DELEGATED AUTHORITY DEVELOPMENT APPLICATION REPORT

DA No. DA09/0635

Lot 2 DP 619871, No. 35-37 Morton Street CHINDERAH

The applicant seeks approval for a warehouse with partial demolition of existing factory and retention of offices and amenities.

Site Plan
1:200

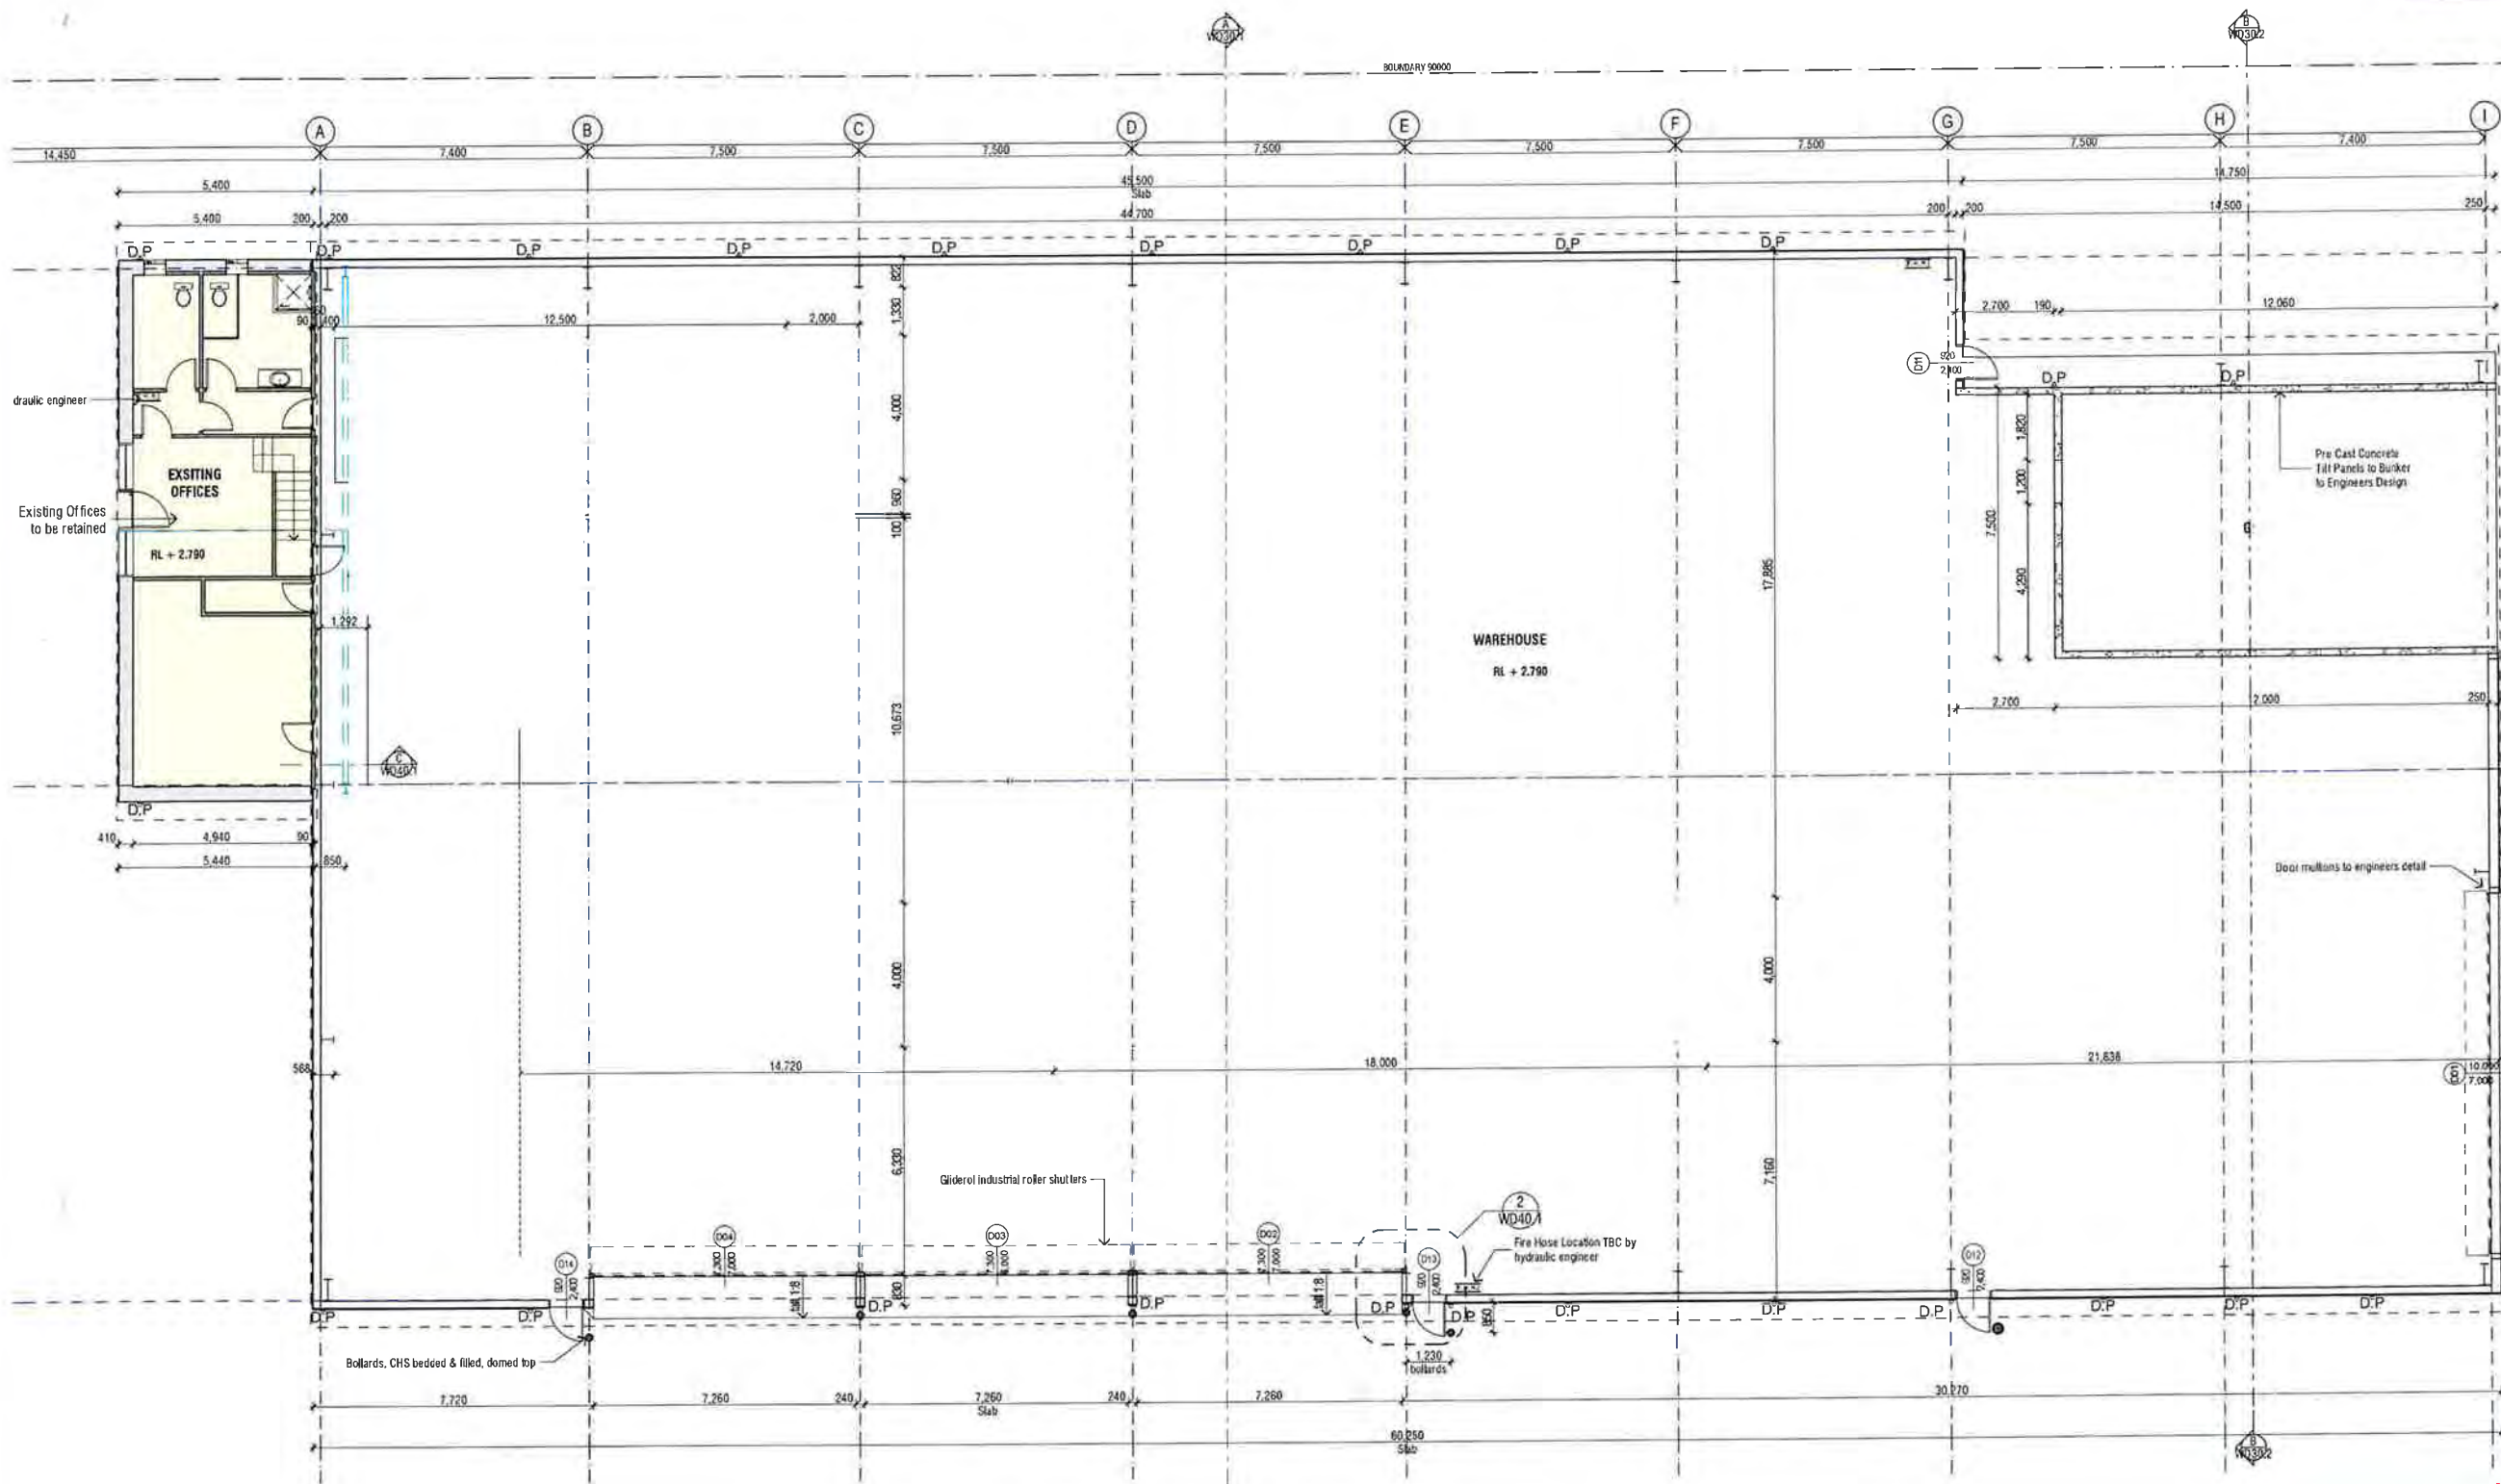
However, detailed assessment of the parking provisions revealed that the 2 spaces off the Morton Street access do not provide adequate turning space (a 6.2m aisle width is required – only 5.235m is available for turning purposes). As such, the 2 separate spaces are not supported, requiring the relocation of 1 space elsewhere on site.

The applicant was advised about the 2 separate spaces not being supported. Rather than providing amended plans, the applicant has requested that Council mark the site plan in red, as necessary. This is considered to be acceptable in this instance given the urgency of determining the application. As a result, the plans have been marked up in red relocating one of the spaces to the proposed 6 spaces fronting Rotumah Street. It appears that there is sufficient room in that area to allow 1 additional space, without impact upon the turning path for the LVR turning path. A condition of consent has been applied requiring detail of the carparking configuration to be approved prior to the issue of a construction certificate. The relocation of the additional space brings the total of approved car spaces to 12, which is compliant with the relevant DCP A2 provisions for warehouses.

Note: The two spaces adjacent to the Morton Street access are to be removed and an additional space is to be located adjacent to the proposed six spaces on the Rotumah Street frontage (as amended in red on the approved site plan).
